Market Change Request

Number		Title	Priority
MCR	0128	MPD 8 (1.1): Changes to Connection Characteristics. Update current procedure to include generators, to satisfy new requirements for SEM Implementation.	<i>HIGH</i>

Date	Version	Reason For Change
15/11/2006	1.1	As detailed in "Responses to AIP MCR Comments". Ref. 4, 22, 28, 29.

2. ARIS Process Flow Diagram (ARIS screenshot)

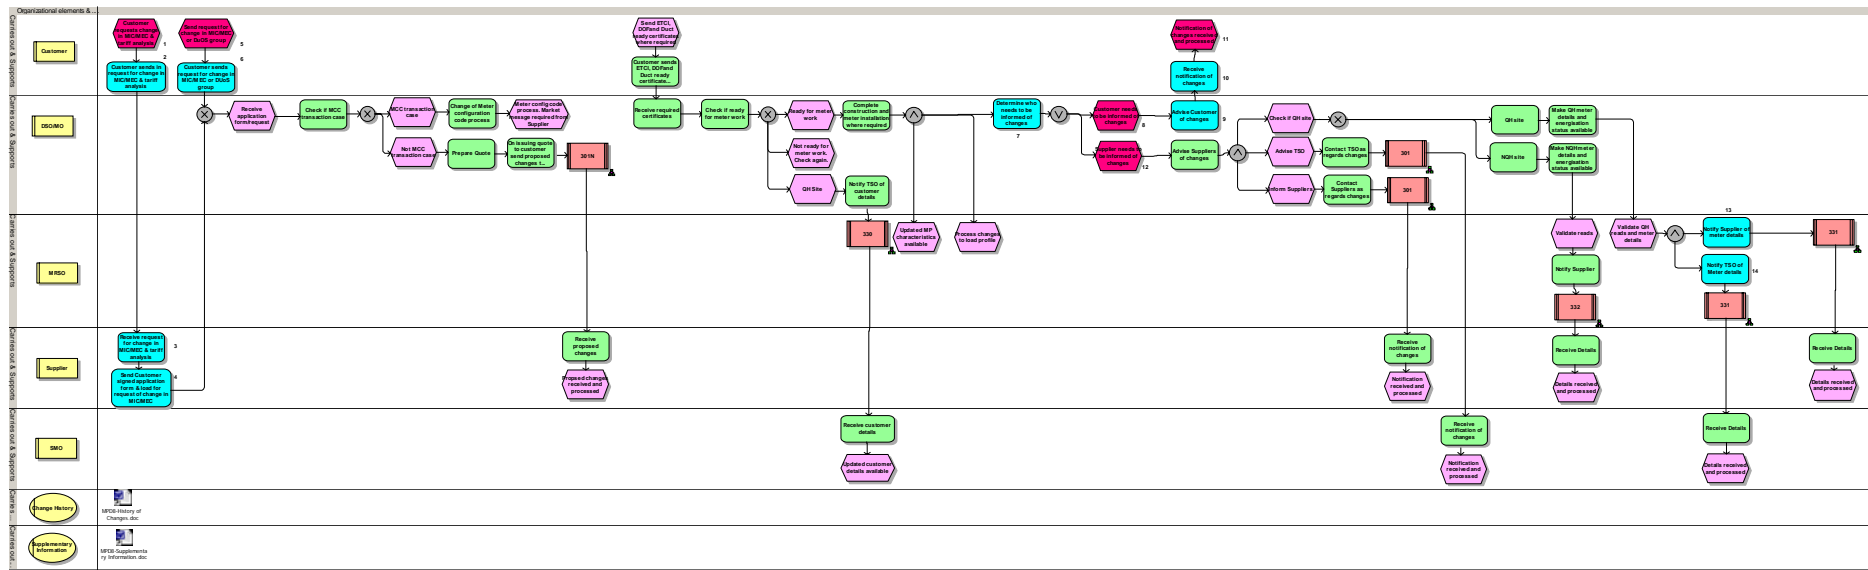
Functions and events will be amended to allow the current process (MPD 8) to cater for generators.

Functions (numbered) and events (numbered) will be amended as in the following ARIS layout.
